190041

Resolution relating to a Certificate of Appropriateness for alterations to a previously approved storefront design at 814 - 816 W. Historic Mitchell Street in the Mitchell Historic District for Hector Salinas.

Approved Plan

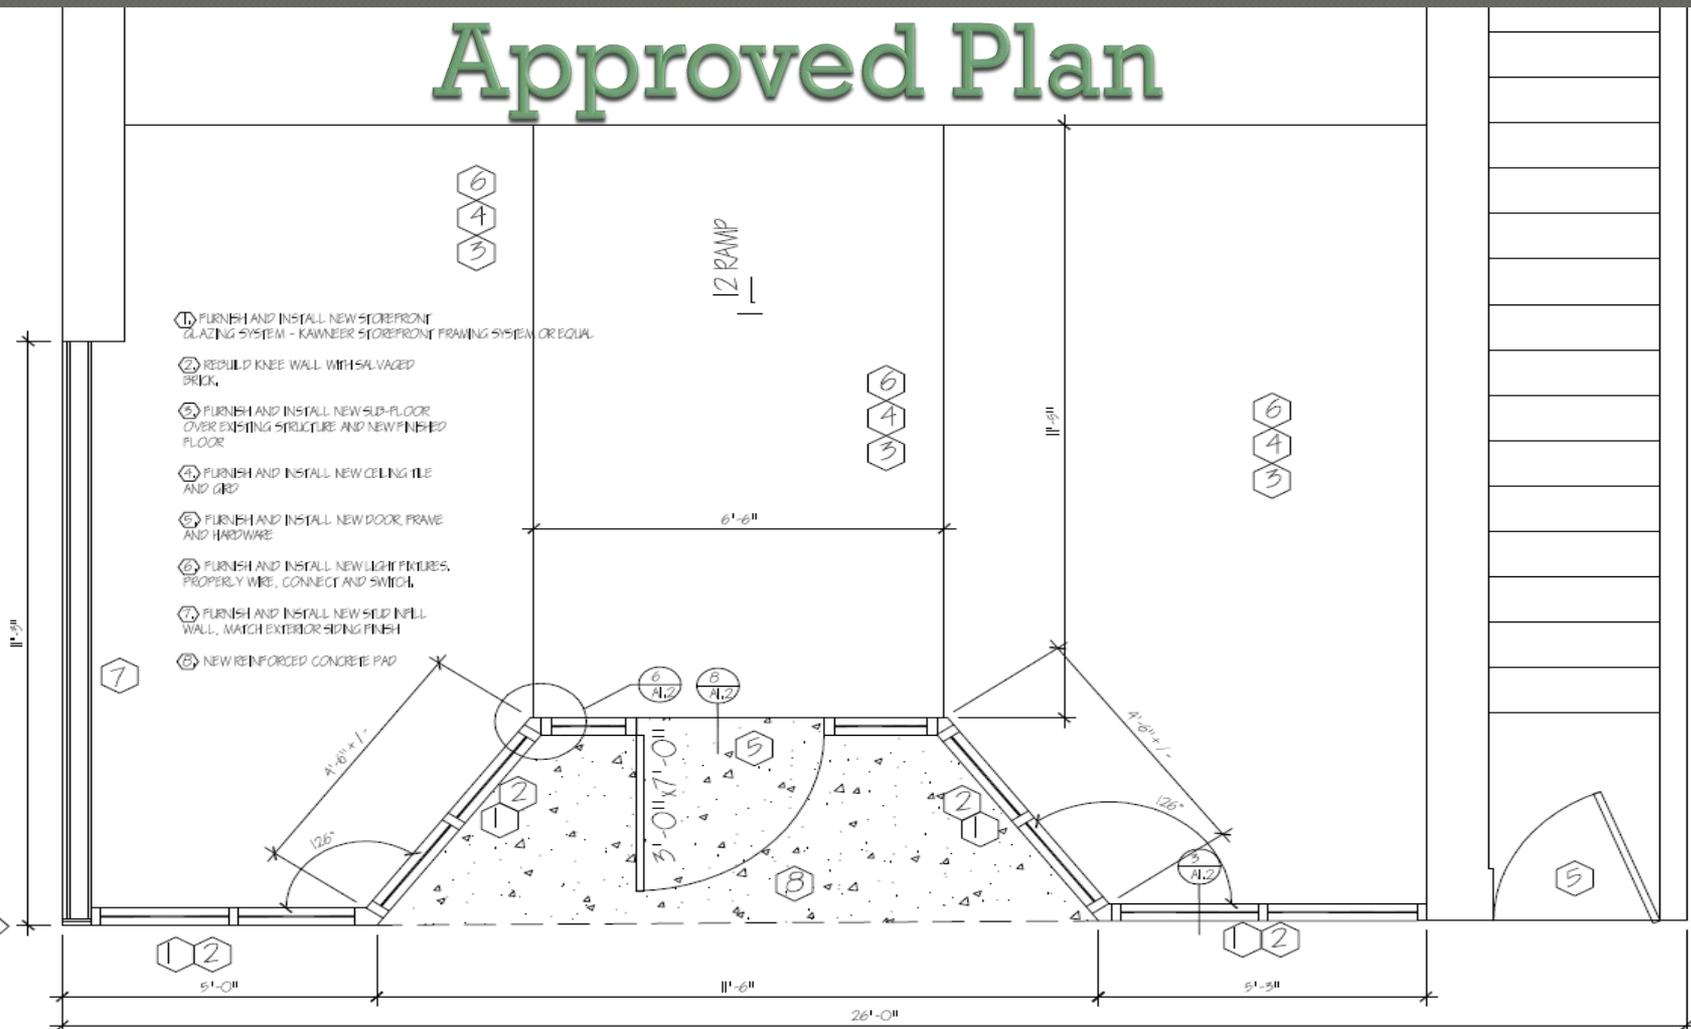
- New aluminum storefront system in anodized black
- Structure requires retaining current bulkhead height
- New door and transom for apartment entrance
- New clapboard infill to restore building above storefront and west wall

As Built

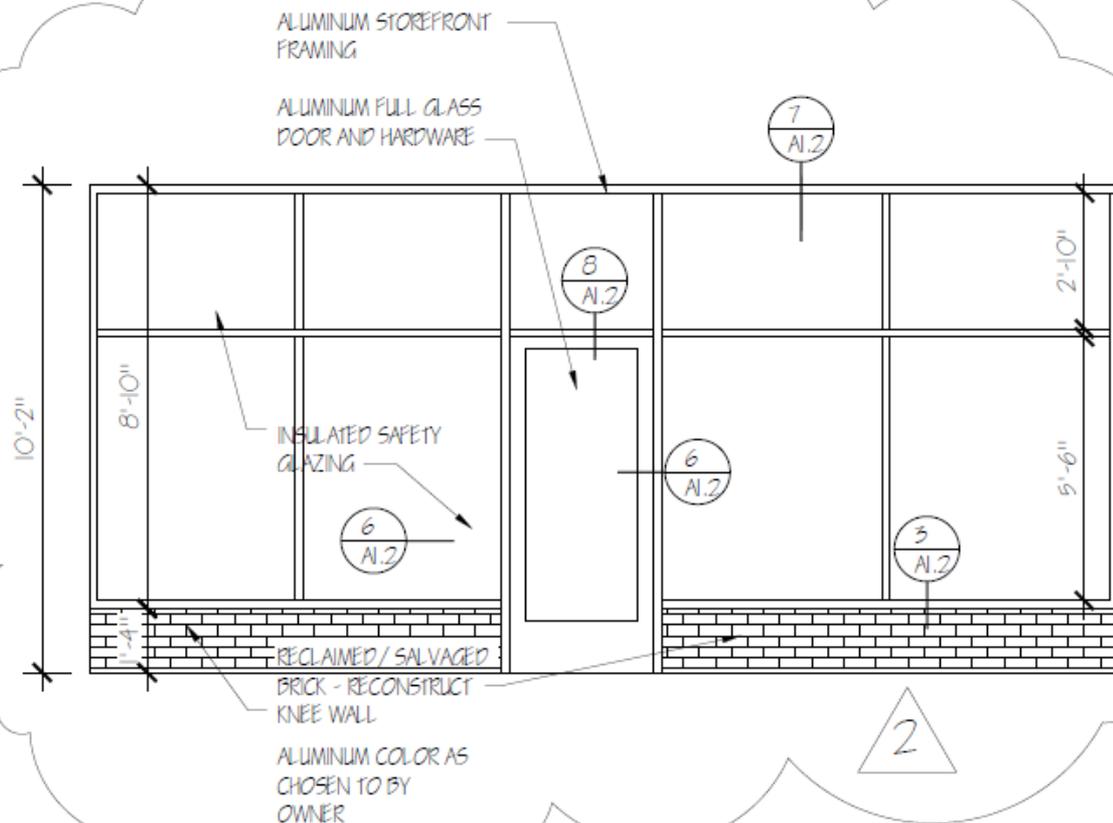
- Built without storefront recess
- Details of header over storefront don't run across whole façade
- Vertical details don't carry up
- Incorrect doors
- Used knotty wood

Recommendation: Deny

- Does not meet standards
- Store entry **MUST** be recessed
- Entry does not need to be as wide as originally drawn
- Build woodwork over storefront and at apartment entry as drawn
